HURRICANE CITY UTAH

Hurricane Planning Commission Meeting Agenda

October 12, 2023
5:00 PM

GOULDING CACTIA
RESIDENTIAL PLAN
PARCEL # H-333-B-1-A
SEC 34, T41S, R13W, SLB&M
220 W 200 N
HURRICANE CITY, UT 84737

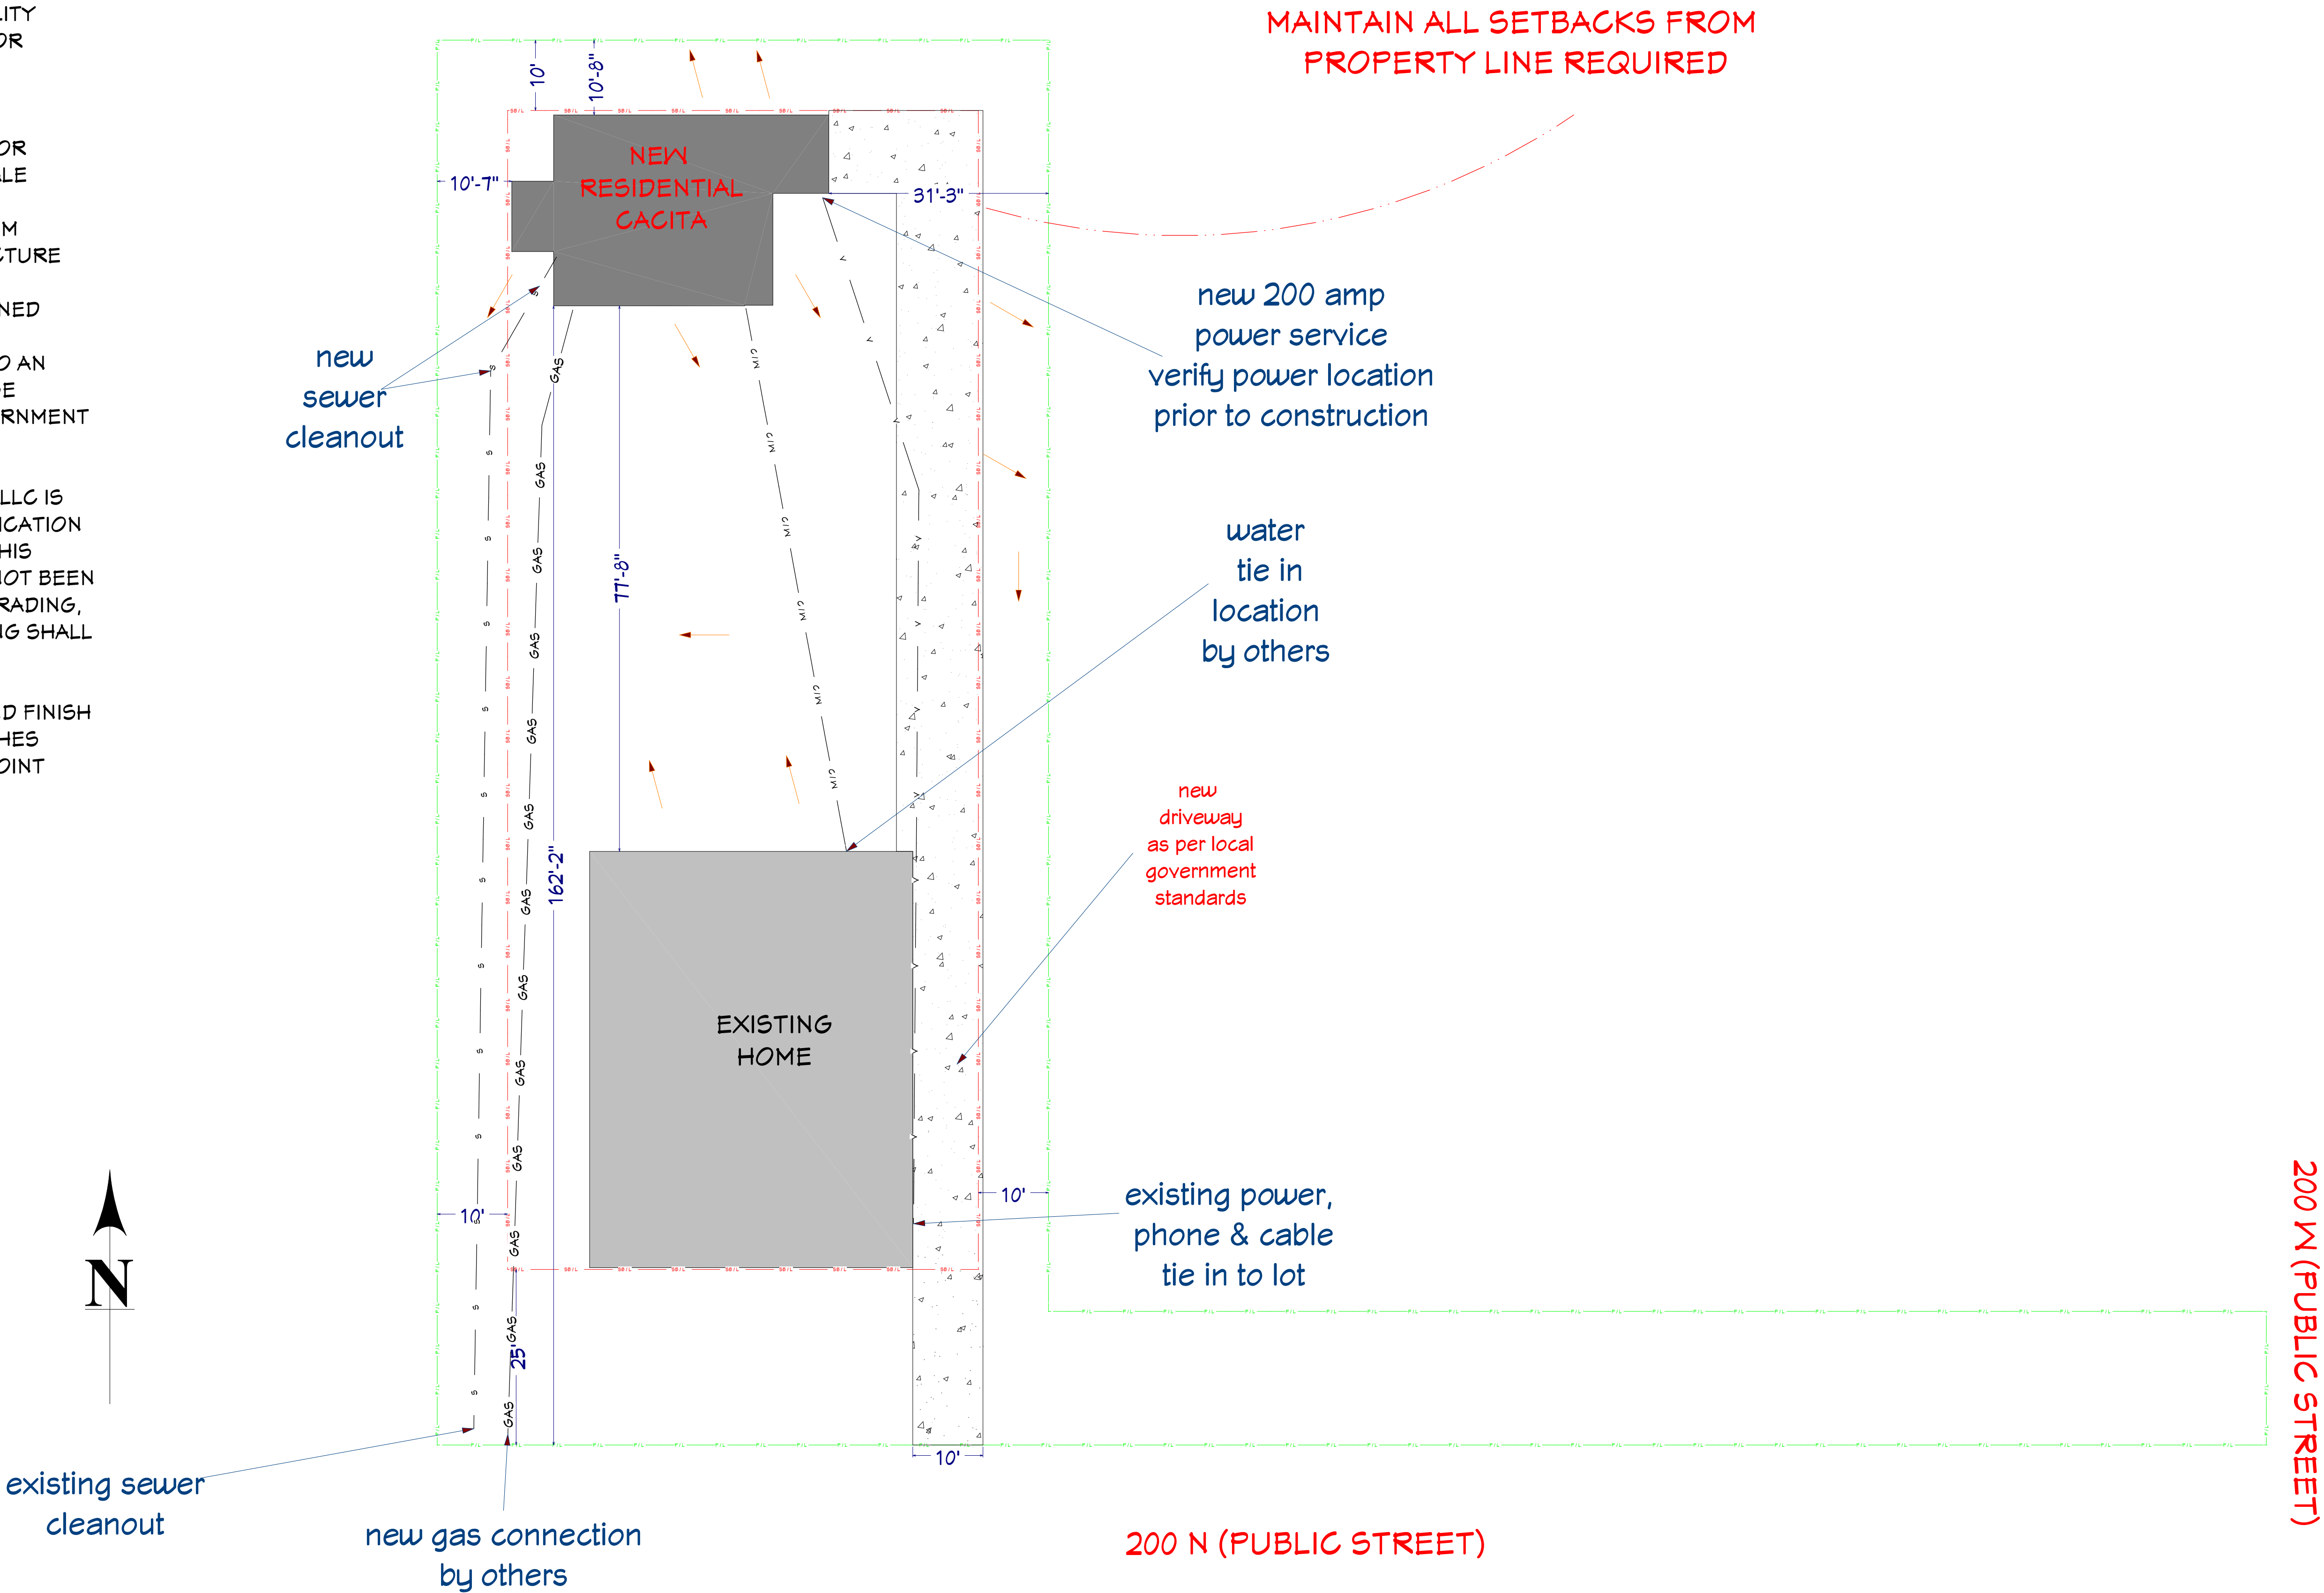
1. The RM-2 zone allows for up to 10 units per acre. One additional unit, with the three units already on site, is compliant with the zoning on the property.
 - a. Per HCC 10-13-3 a “casita” as they have put on their plans is not permitted in this zoning; however, staff deems the proposed use as a single-family dwelling, which is permitted.
2. Parking Requirement: Per HCC 10-34-10:

It is not clear that the site plan proposed meets this code, but the site plan shows adequate space on site for two additional parking spaces.

Recommendation: Staff recommends the Planning Commission review this application based on standards with Hurricane City Code. Staff recommends approval subject to staff and JUC comments.

DOOR OPTIONS

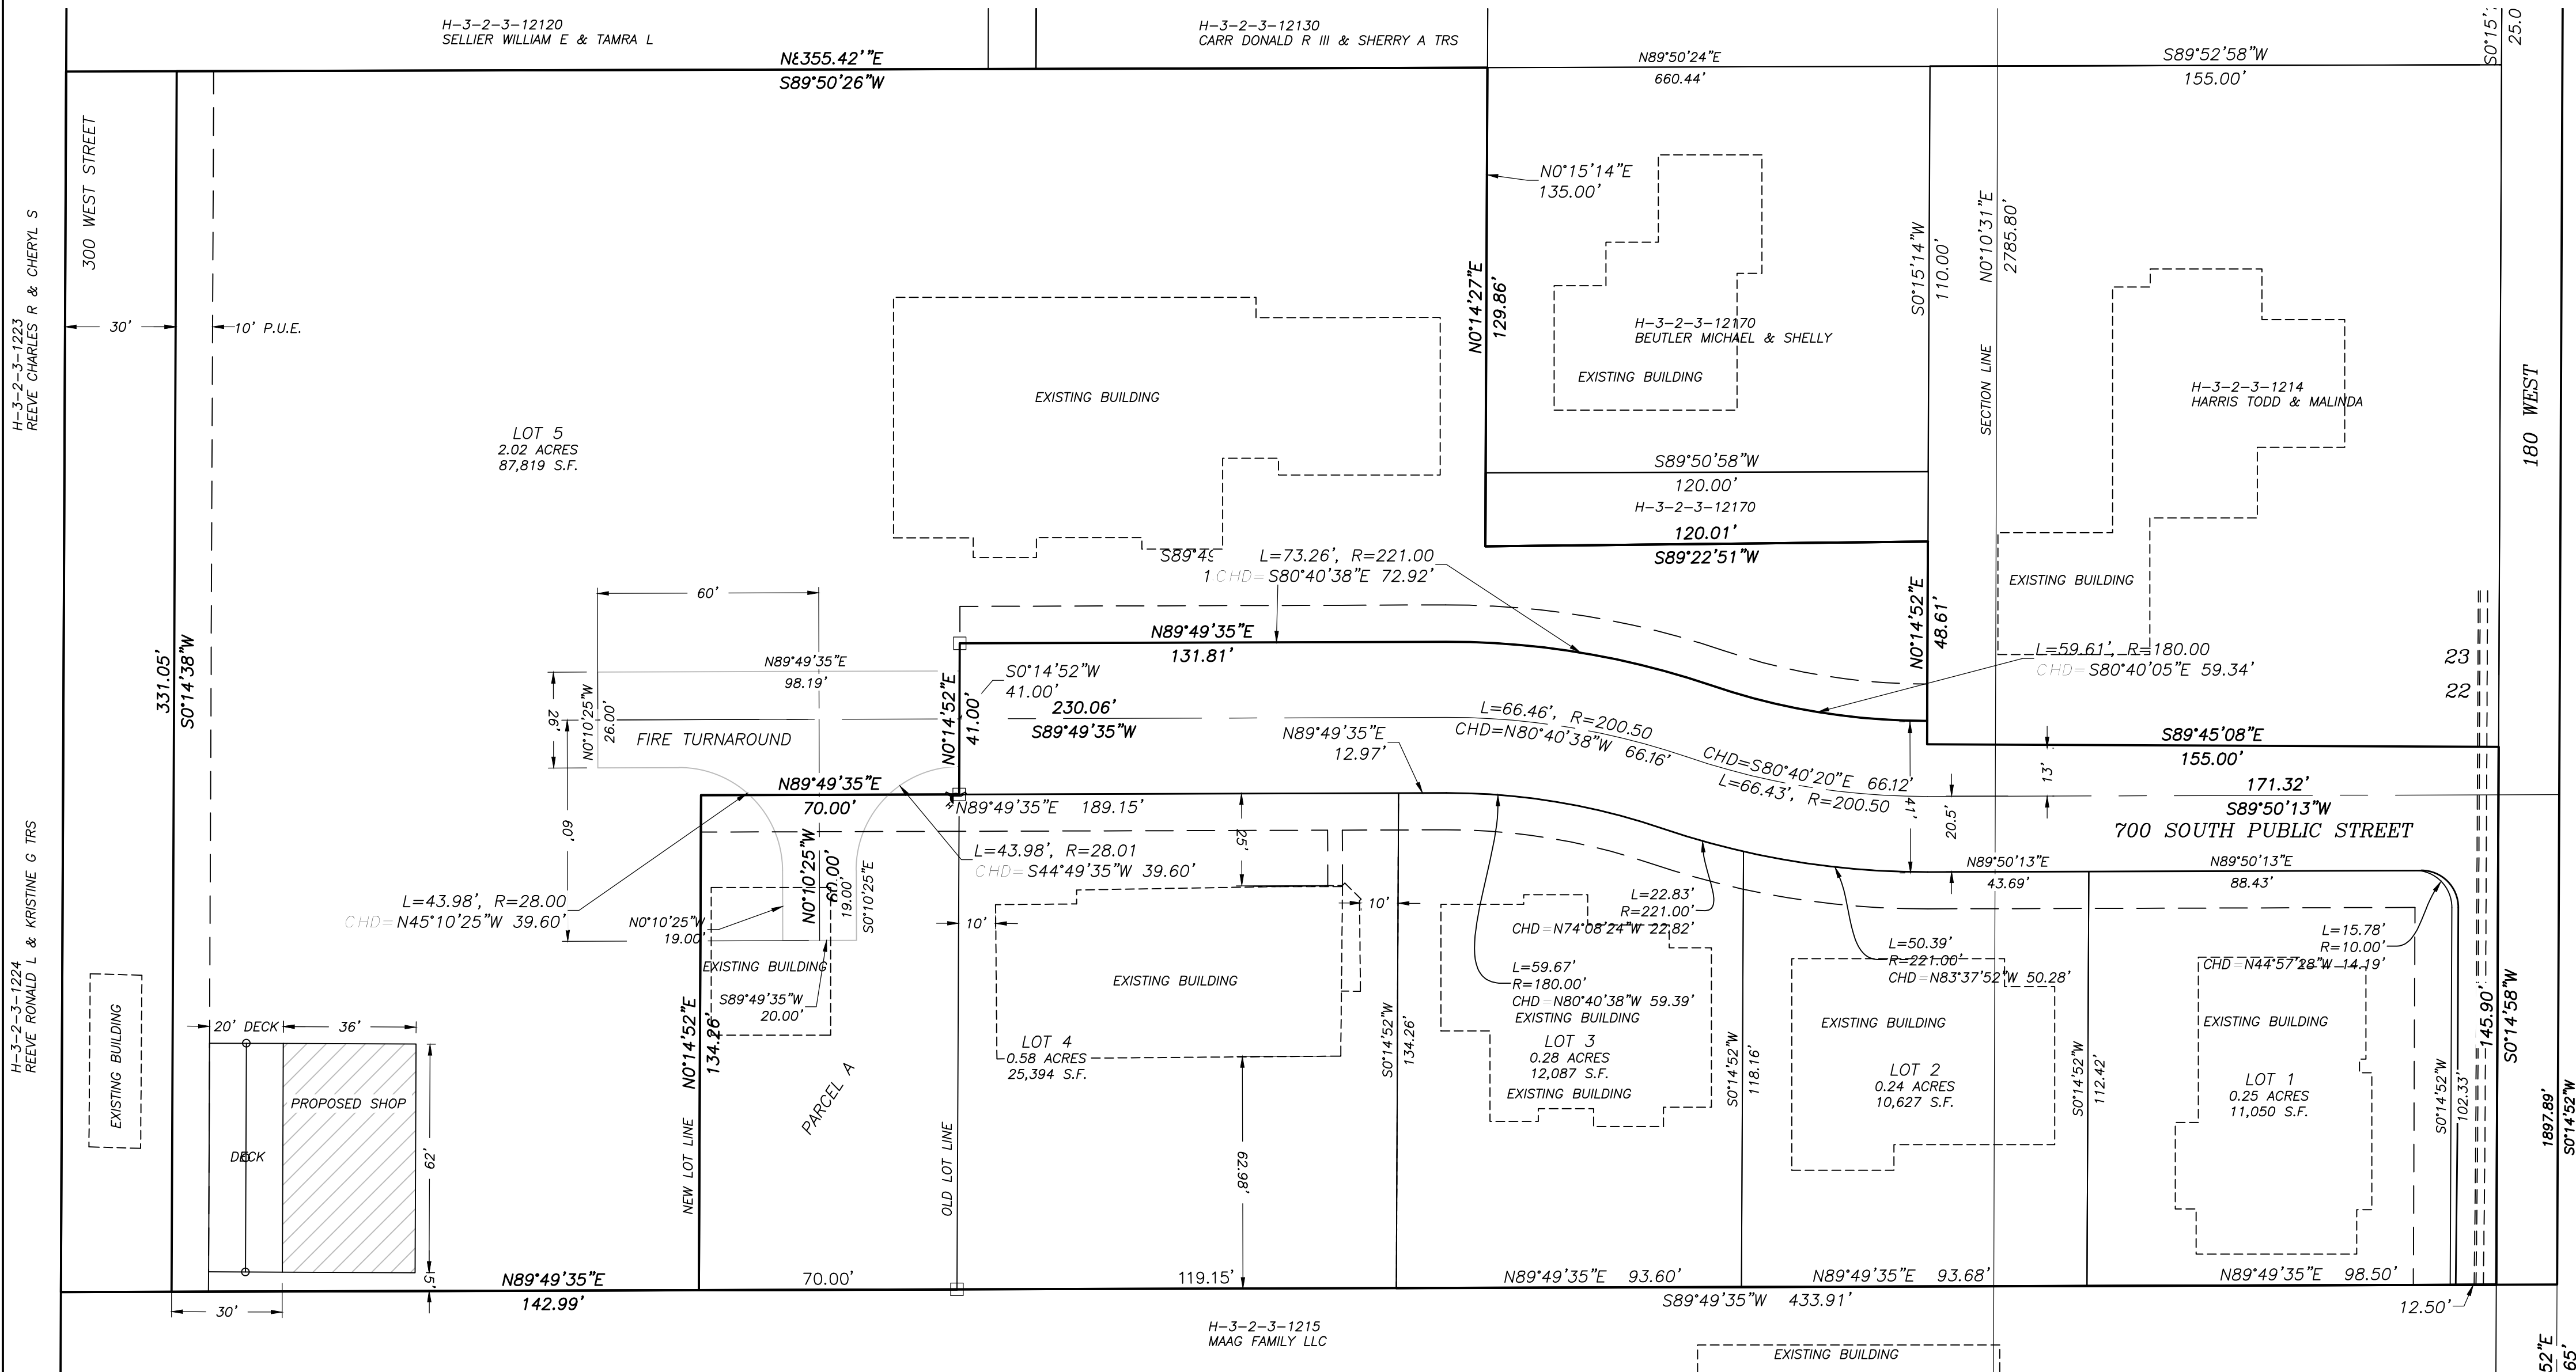
1. There is a 67'' master planned roadway (Future 300 W) that is already dedicated along the property's western boundary that needs to be accounted for in the development of this property.

Recommendation: Staff recommends the Planning Commission review this application and the zone change based on standards and consider any public comments. Staff recommends approval of the proposed zone change.
